### NOTICE OF INTEREST, BUILDING REQUIREMENTS, AND ESTABLISHMENT OF RESTRICTIVE COVENANTS

**Geotechnical Study  
Meadow Brook  
approximately 600 South 6600 West  
American Fork, Utah**

**Re: Response to Review**  
**Meadow Brook**  
**600 South 6600 West**  
**American Fork, Utah**  
**Project No: 228636**

Subject Document: Earthtec Engineering, Response to Review, Meadow Brook, 600 South 6600 West, American Fork, Utah, Earthtec Project No. 228636, prepared for Ms. Ginger Romriell, Woodside Homes of Utah, LLC, 460 West 50 North, Suite 300, Salt Lake City, Utah 84101, dated August 12, 2022.

# AERIAL PHOTOGRAPH SHOWING LOCATION OF BORING IN RELATION TO SUBJECT SITE

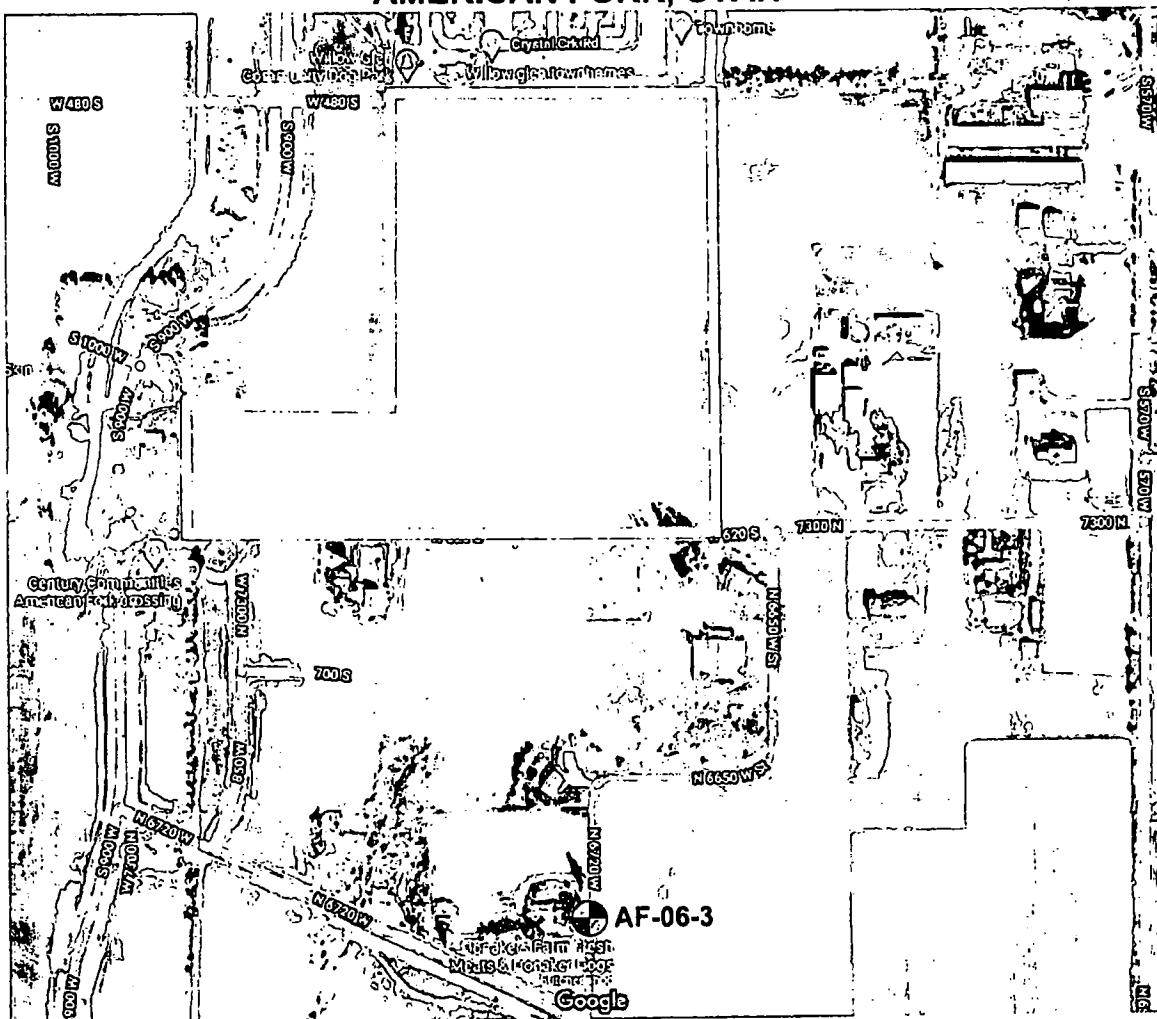
*The RB&G, 2006, report specifies for facilities designed according to the IBC seismic provisions and located within the moderate or high liquefaction hazard zones identified on Figure 6 of the RB&G report, that the recommended Site Class be based on a site-specific subsurface investigation to a depth of at least 30 feet, supplemented by at least one investigation to a depth of at least 70 feet and located within 2,000 feet of the site (see page 17, RGB 2006).*

*The Earthtec report did not supplement their report with at least one investigation to a depth of at least 70 feet within 2,000 feet of the site. TG recommends the City request Earthtec provide the recommended Site Class in accordance the City Sensitive Land Ordinance with:*

Boring AF-06-3 is within 2,000 feet of the subject site. A site plan showing the location of the boring in relation to the site is provided at the end of this response. A log of the boring is also provided at the end of this response. Based on this boring the site class is borderline D/E.
